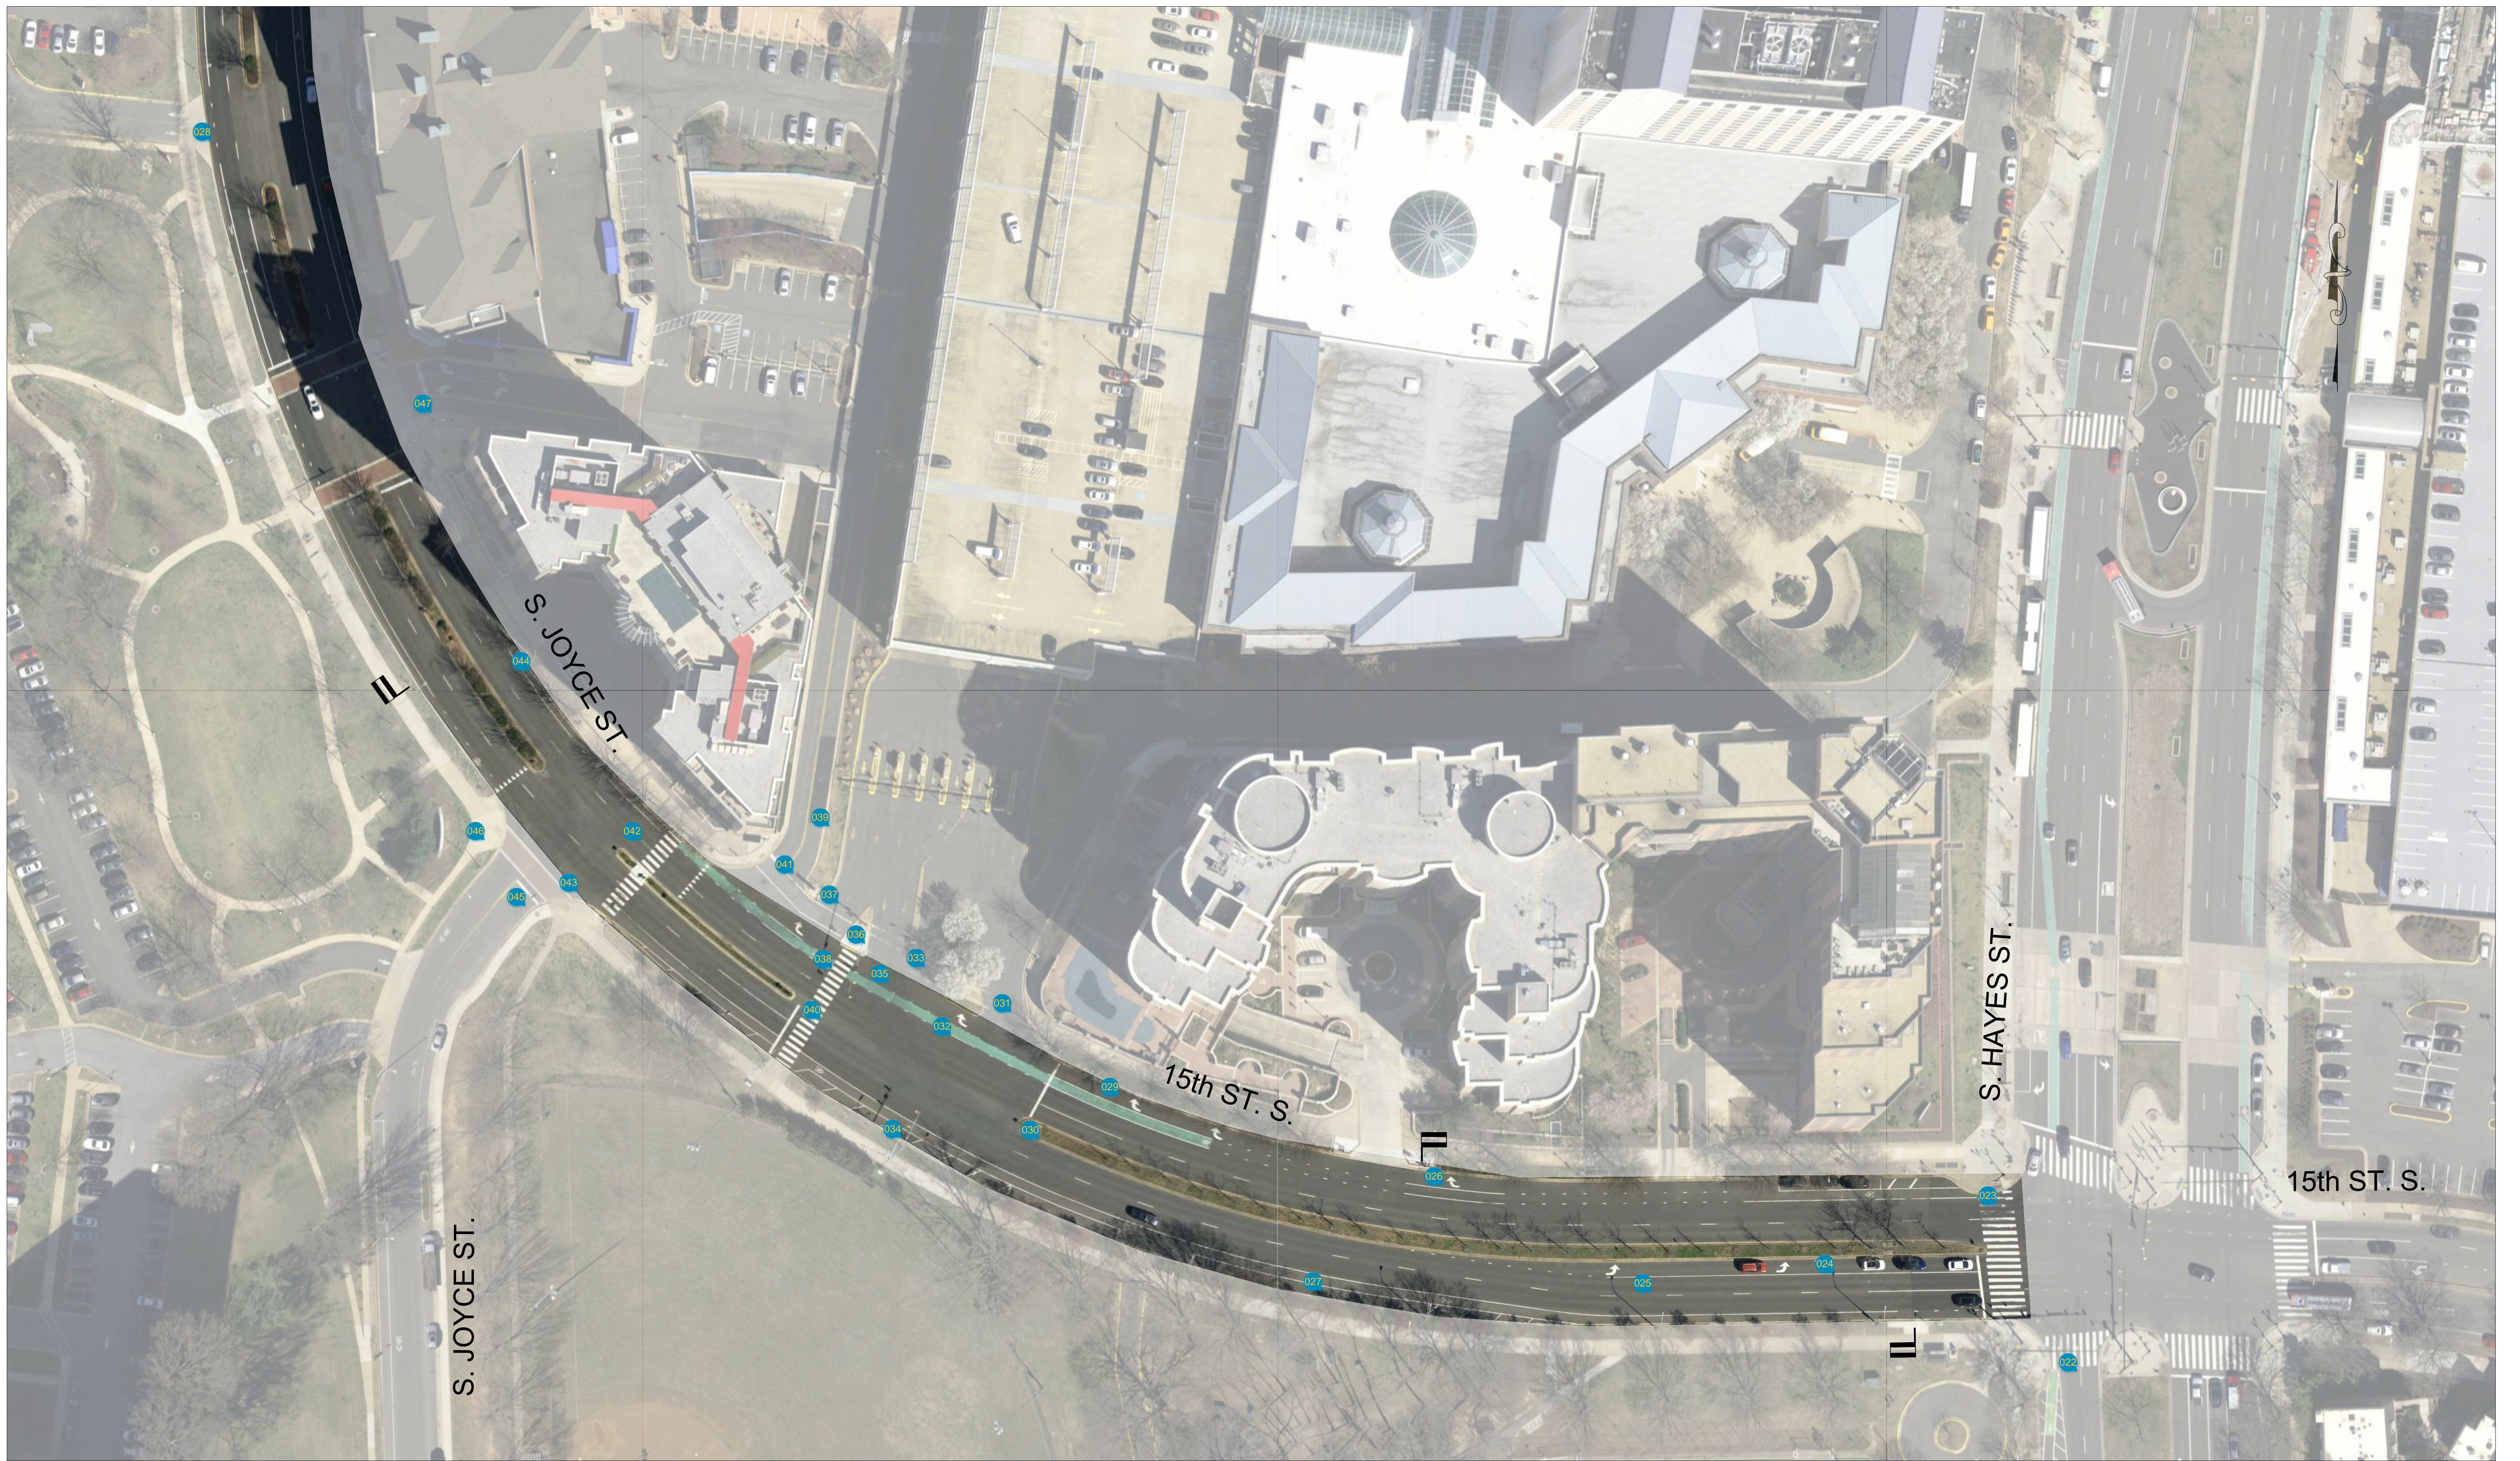
The west sidewalk on this section Joyce is too narrow.

Please add ped bumpouts at A-ND and Joyce - perhaps drivers might see us more easily before then turn into us.

While outside the scope of this effort, please ensure a better route for cyclists heading north is provided on upcoming projects. Crossing A-N Drive on Joyce pushes the cyclist to the east into the slip lane to get to the curb cut. Motorists on A-N Dr (Westbound) are not looking for people riding there. Move the curb cut to the west, or install another.

I think the left turn lane likely can be eliminated here, it does not seem highly used

There are six lanes at this location providing a left and right turn pocket. Do the volumes at this location warrant these? Are the potential time saves to keep them worth not achieving the potential safety gains by eliminating them?

Can these car lanes be narrowed within Westpost to encourage slow exits?

Bike lane lacks visibility at the entrance apron. Additional visibility for drivers entering/exiting here would make this segment safer.

Please add ped bumpouts at the corners to give us shorter crossing distances. Can you do anything through this prject to keep drivers from turning left into us when we're trying to cross? Very dangerous.

Pedestrians regularly cross Joyce at this intersection to reach Harris Teeter dodging vehicles turning into and out of the West Post parking lot.

As part of the paving project, please install the conduit necessary to permit installation of a RRFB for the crosswalk that is necessary here. The RRFB may need to wait for some ArCo study but any conduit in the pavement would be prudent

At both unsignalized crosswalks - please repaint the crosswalks brighter and wider - and add bulb-outs at the medians to protect crossing peds and encourage drivers to turn correctly.

This bike lane seems to always be blocked by double-parked or just poorly-parked vehicles.

Please add PBL on both sides of Joyce and along 15th - for this entire stretch of repaving. Reduce travel lanes to one on each side as needed.

Large amount of loading/unloading occurs here (see delivery vehicles in Google streetview). Is this the right location for that here?
